Access Compliance Report

Public Rights-of-Way

(Curb Ramps)

Intersection ID: 54218	Main Street: GOLF_LINKS_DR	Cross Street: SANDY_ROCK_PL	Location: SE
ADA ID: F48EAEAE220C	Ramp Type: Directional1	Initial Pass/Fail: Fail	Overall Compliance: No
		Severity Score: 12.5	
Codes/Mitigation Info/Possible Solution		Field Measurements/Component Compliance

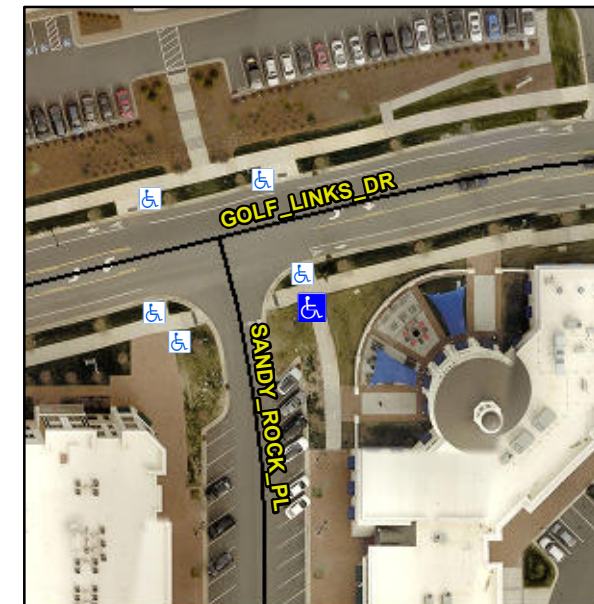
R304.2.2

Compliance	Description	Data	Compliance	Description	Data
N/A	Ramp Length (in)	87.0	N/A	Grade Break?	N/A
Yes	Ramp Width (in)	87.0	N/A	Grade Break Slope (%)	0.0
No	Ramp Slope (%)	9.6	N/A	Grade Break XSlope (%)	0.0
Yes	Ramp XSlope (%)	0.7			
N/A	Flare Type LT	N/A	N/A	Flare Type RT	N/A
N/A	Flare Slope LT (%)	N/A	N/A	Flare Slope RT (%)	0.0
N/A	Flare Traversable LT?	N/A	N/A	Flare Traversable RT?	N/A
N/A	Landing Length (in)	0.0	N/A	DWS Provided?	N/A
N/A	Landing Width (in)	0.0	N/A	DWS Contrast?	N/A
N/A	Landing Slope (%)	0.0	N/A	DWS Length (in)	N/A
N/A	Landing X Slope (%)	0.0	N/A	DWS Full Width?	N/A
N/A	Landing Curb? (Y/N)	N/A	N/A	DWS Offset LT (in)	N/A
N/A	Shared Landing?	N/A	N/A	DWS Offset RT (in)	N/A
N/A	Gutter Ponding?	0.0	N/A	Gutter Slope (%)	N/A
N/A	Gutter Lip Ht (in)	0.0	N/A	Gutter X Slope (%)	N/A
N/A	Painted X Walk1?	No		Road Slope (%)	0.6
	X Walk 1 Direction	To W		Road X Slope (%)	0.5
	X Walk 1 Width (in)	N/A		Clear Space?	N/A

Remove & Replace Entire Ramp.
